CALL NO. 327
CONTRACT ID NO. 142114
ADDENDUM # 1

Subject: McLean County, FD05 075 0431 000-003
Letting September 26, 2014

- (1) Revised - Typical Sections - Pages 24-26 of 74
- (2) Added - Special Notes - Pages 26(a)-26(b) of 74
- (3) Revised - Bid Items - Page 74 of 74

MCLEAN COUNTY
FD05- 075-0431-000-003
TYPICAL SECTION
MP 0.00 TO MP 2.582

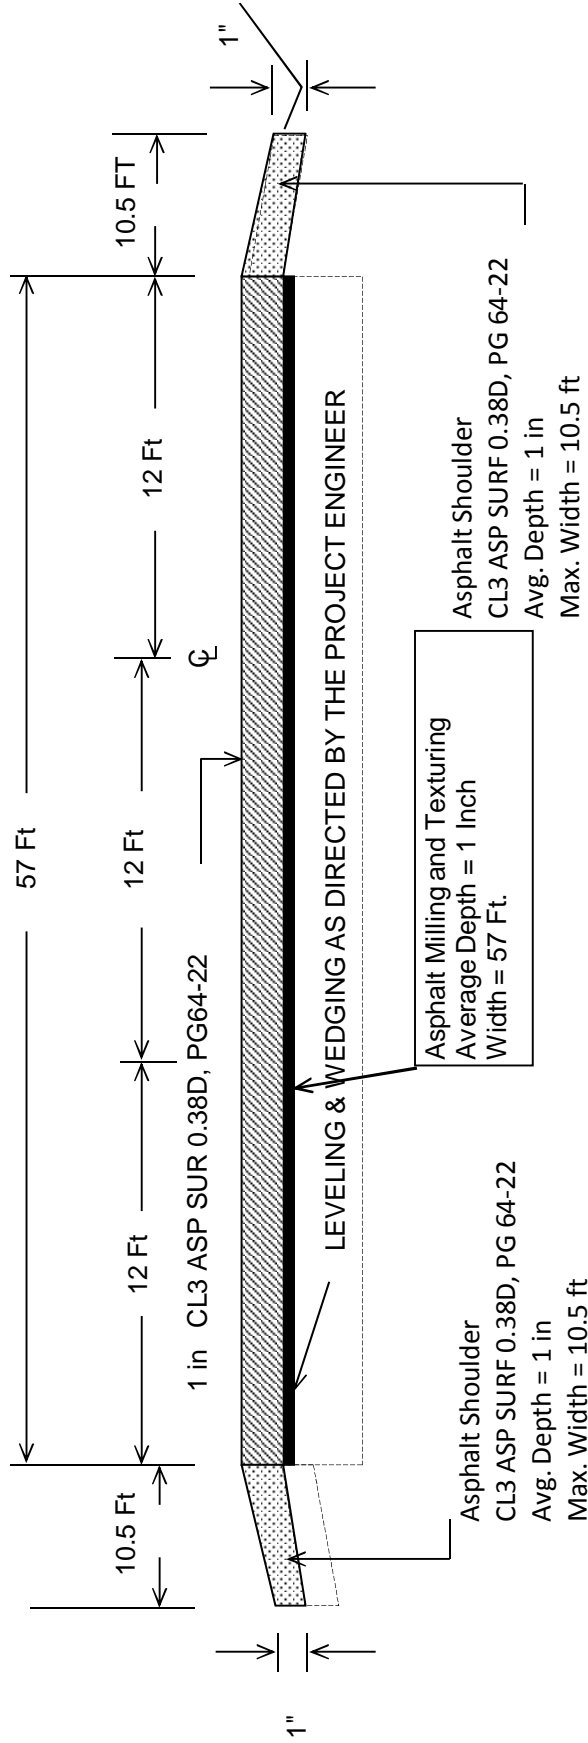
CONSTRUCT CENTERLINE RUMBLE STRIPES FROM MP 0.000-1.939 AND MP 2.512-2.766

MCLEAN COUNTY
FD05 075 0431 000-003
TYPICAL SECTION (3 LANE SECTION)
MP 2.582 TO MP 2.766

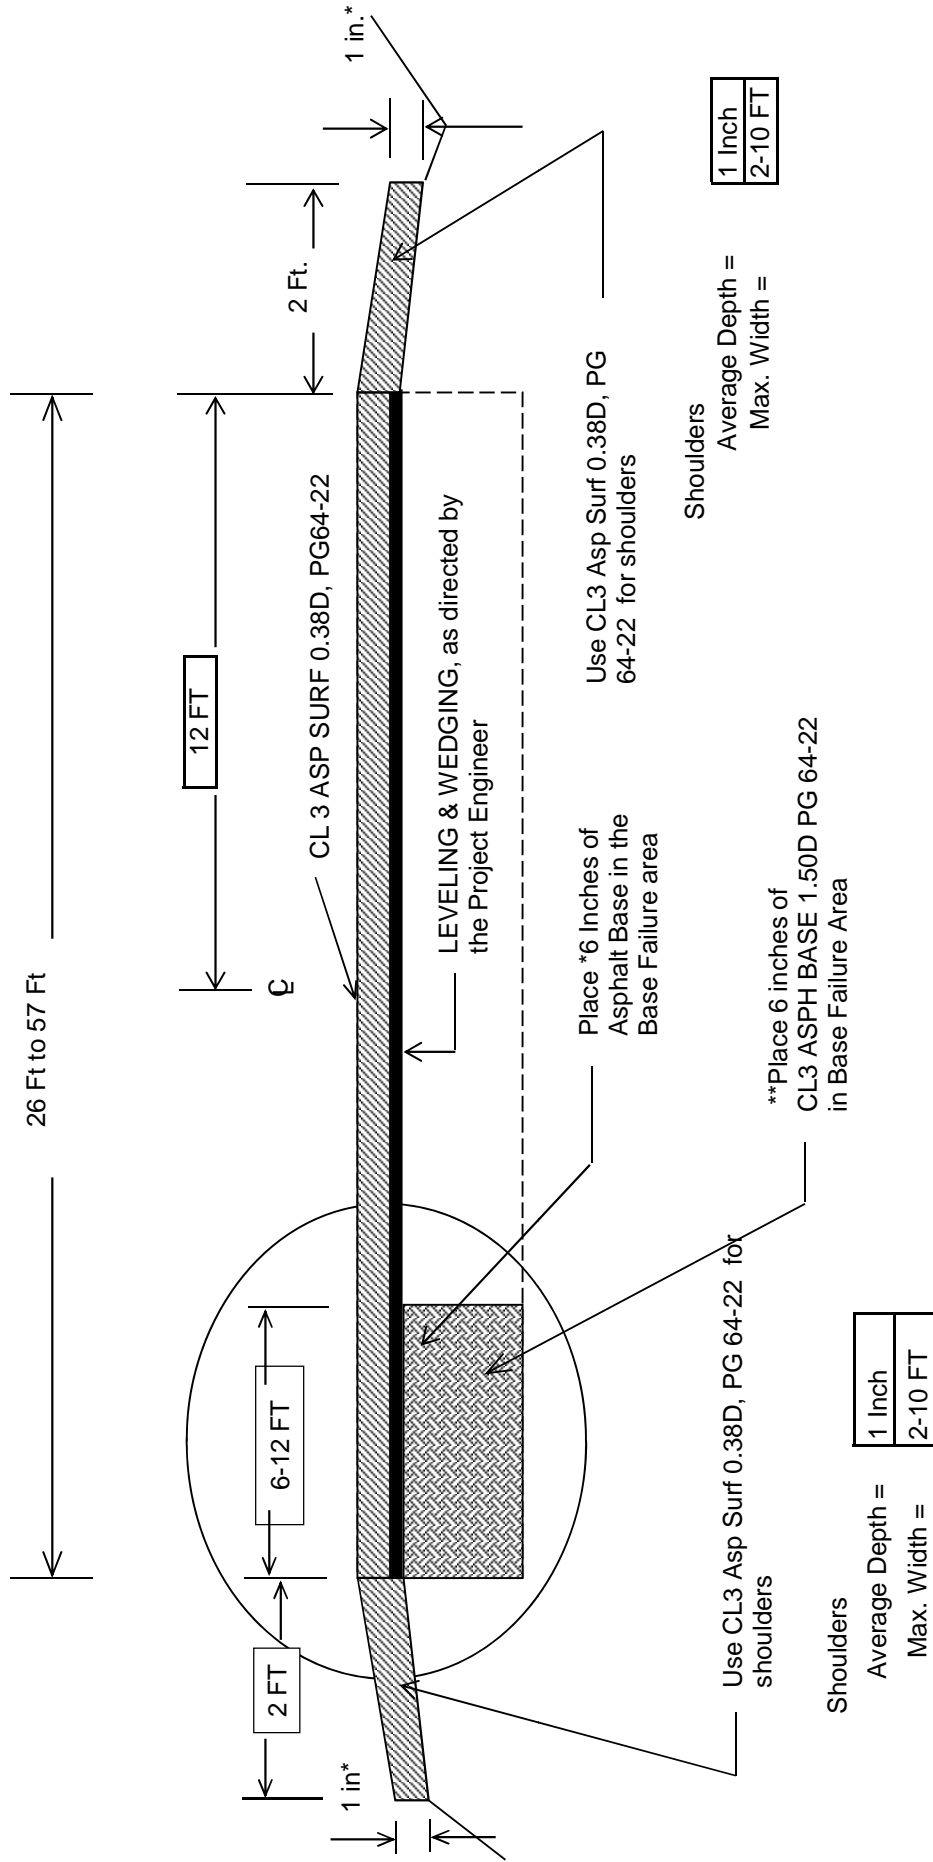
CONSTRUCT CENTERLINE RUMBLE STRIPES FROM MP 0.000-1.939 AND MP 2.512-2.766

CENTERLINE RUMBLE STRIPS

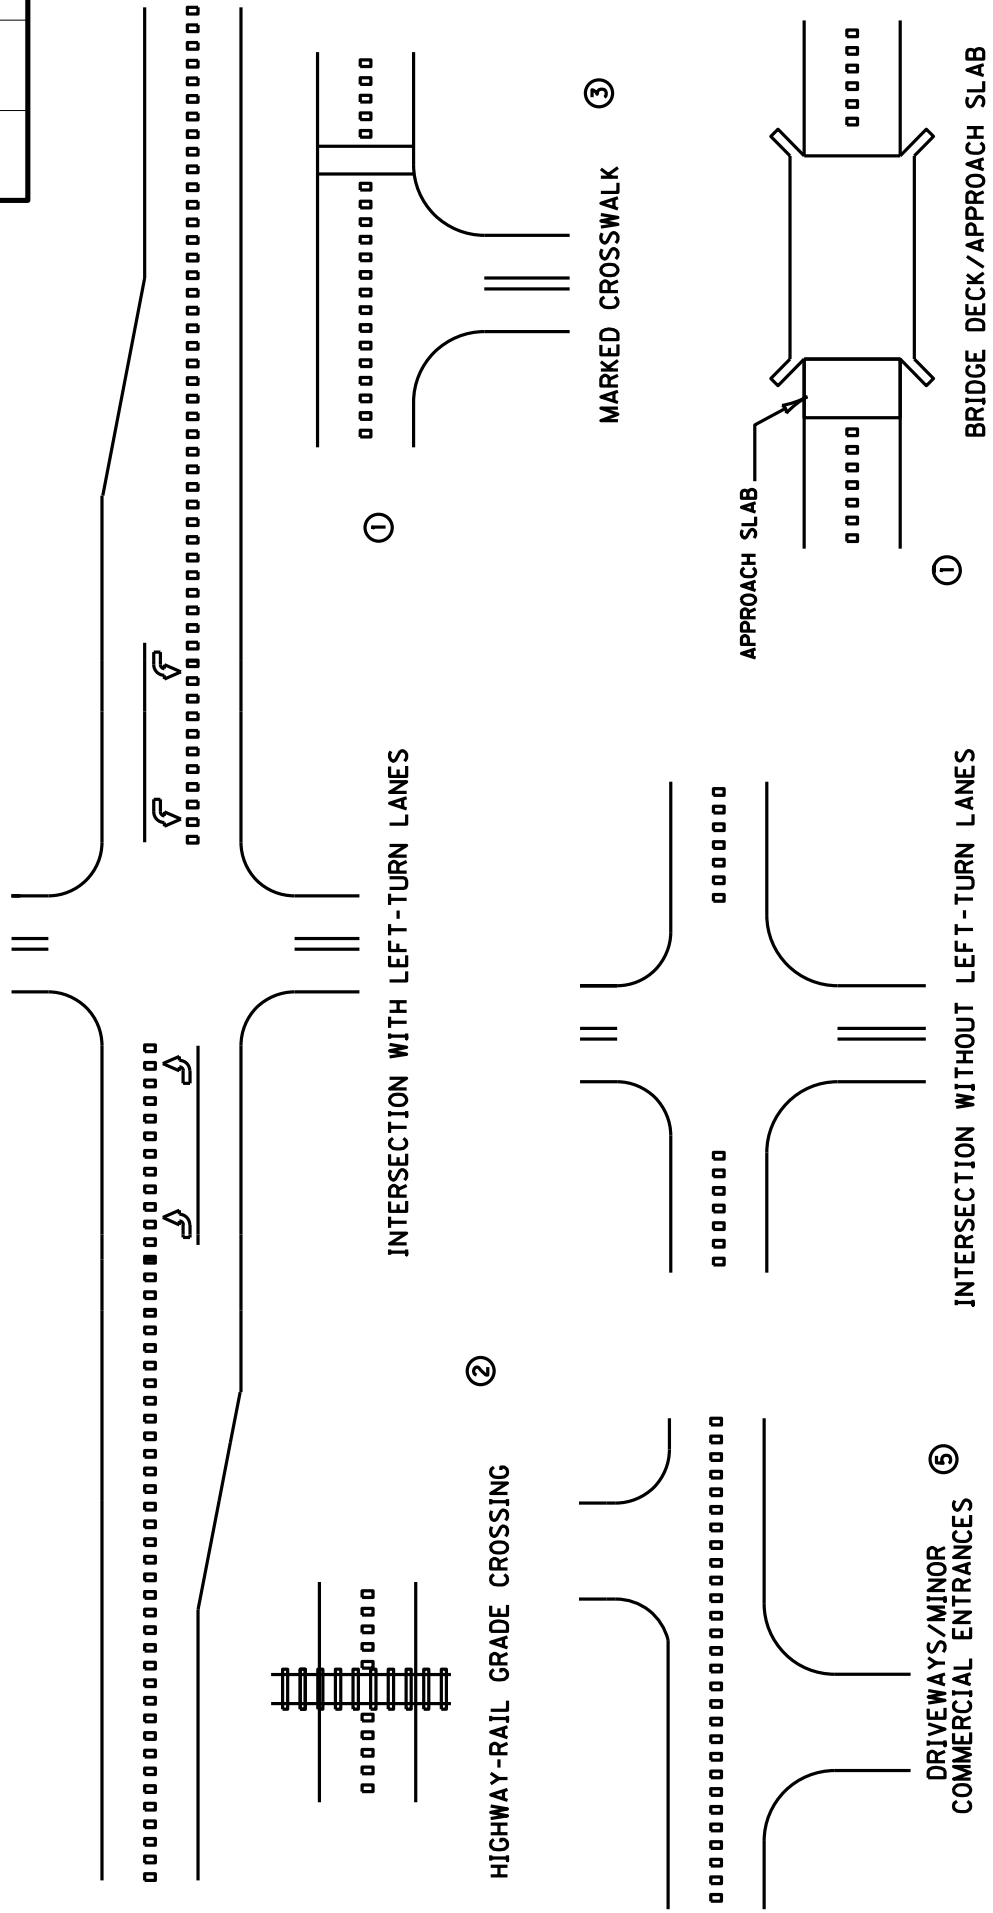
Construct Centerline Rumble Stripes at the locations listed on the Typical Sections. The milepoints listed are approximate only; the Engineer will determine exact milepoints at the time of construction. Contrary to Section 713, the existing striping pattern may change on the project. See attached drawings for Centerline Rumble Stripe Installation Details. Unless directed otherwise by the Engineer, DO NOT install Centerline Rumble Stripes where the posted speed limit is 45 MPH or less. If questions arise regarding changes in striping patterns or termini of the Centerline Rumble Stripes, obtain guidance from the District Traffic Engineer.
